# Access Compliance Report

## Public Rights-of-Way

### (Curb Ramps)

| Intersection ID: 12056 | Main Street: ELLIOTT_ST | Cross Street: N_I-77_EXIT_10A_RA | Location: NE           |

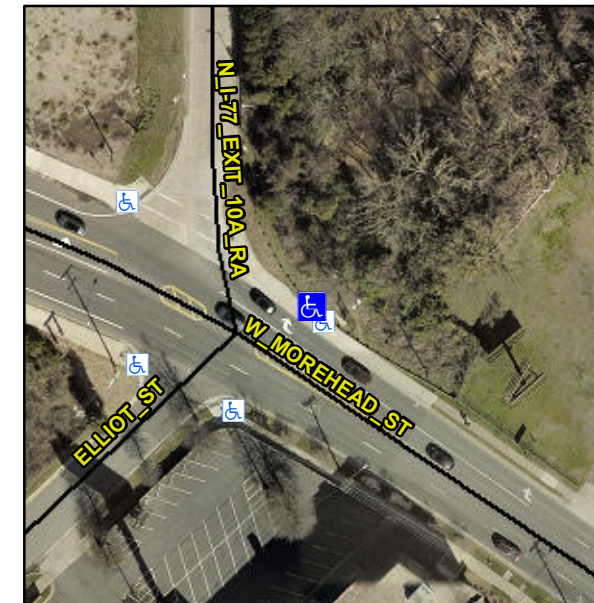
Surveyor Notes:

**RT RP < 5%**

PROW/ADA:

**R304.2.1, R304.2.2-Perp, R304.3.2-Para, R304.5.3, R305.2**

| Compliance | Description           | Data                 | Compliance | Description                 | Data   |
|------------|-----------------------|----------------------|------------|-----------------------------|--------|
| No         | Landing Length (in)   | N/A                  | Yes        | DWS Provided?               | Yes    |
| No         | Landing Width (in)    | N/A                  | Yes        | DWS Contrast?               | Yes    |
| No         | Landing Slope (%)     | N/A                  | Yes        | DWS Length (in)             | 24.0   |
| No         | Landing X Slope (%)   | N/A                  | Yes        | DWS Full Width?             | Yes    |
| N/A        | Landing Curb? (Y/N)   | Yes                  | No         | DWS Offset (in)             | 4.0    |

Possible Solutions:

**Remove & Replace Entire Ramp.**
